10/696,758

REMARKS

Annotated Marked-Up Drawing

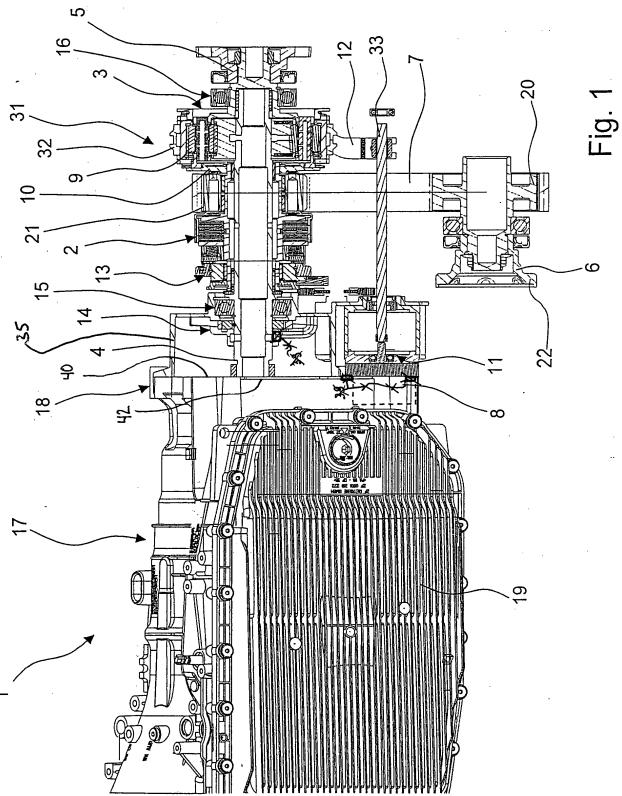
The drawings are objected to for the reasons noted in the official action, e.g., the failure to show the first end face, the corresponding end face and the auxiliary transmission housing. All of the raised drawing objections are believed to be overcome by the requested drawing amendments accompanying the attached Submission. New Replacement Sheets of the formal drawings, accompany this Submission, and incorporate all of the requested drawing amendment(s). If any further amendment to the drawings is believed necessary, the Examiner is invited to contact the undersigned representative of the Applicant to discuss the same.

Based upon this description, it is respectfully submitted that the claimed damper could be, for example, a piece of rubber, or some other conventional and well known damper material located between the connection of the end face of the electric motor with the mating end face of the main transmission unit housing. The specification is believed to clearly provide support for the previously submitted drawing amendment. Notwithstanding this clarification, the subject matter of claim 11 is canceled, without prejudice or disclaimer thereof, from this application and paragraph 33 and the previously requested drawing amendment are both accordingly amended.
